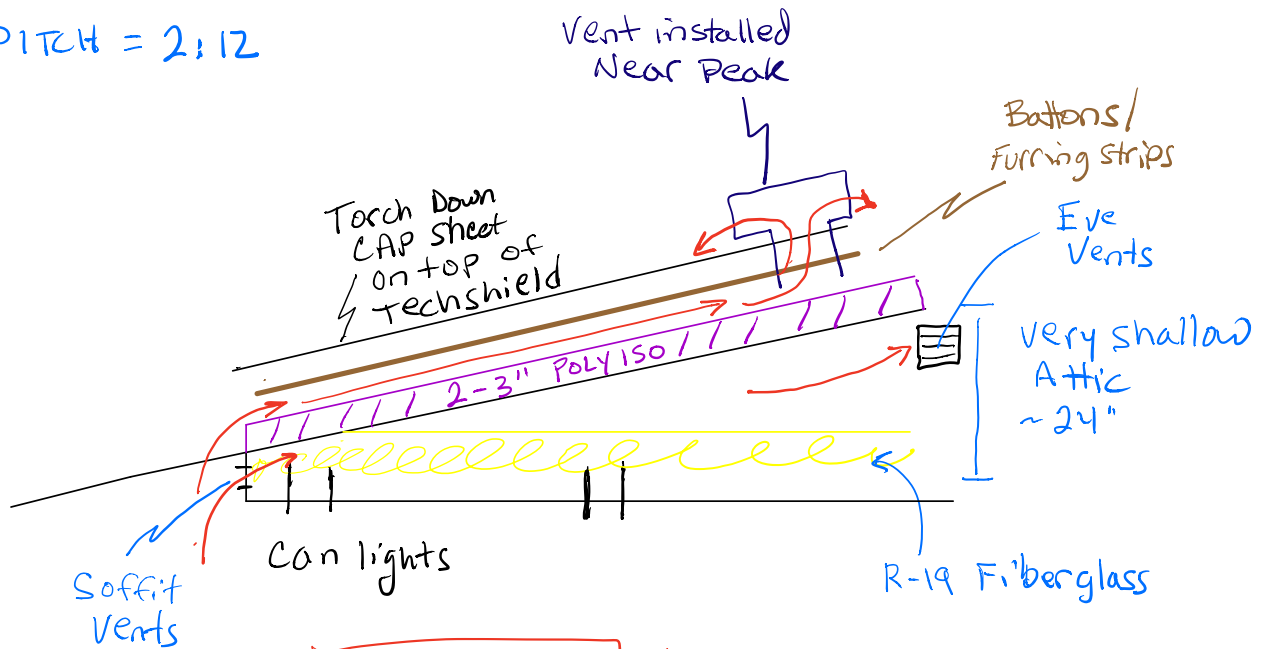
□ IS 2:12 PITCH ENOUGH FOR AIR TO FLOW LIKE THIS ABOVE THE POLYISO?
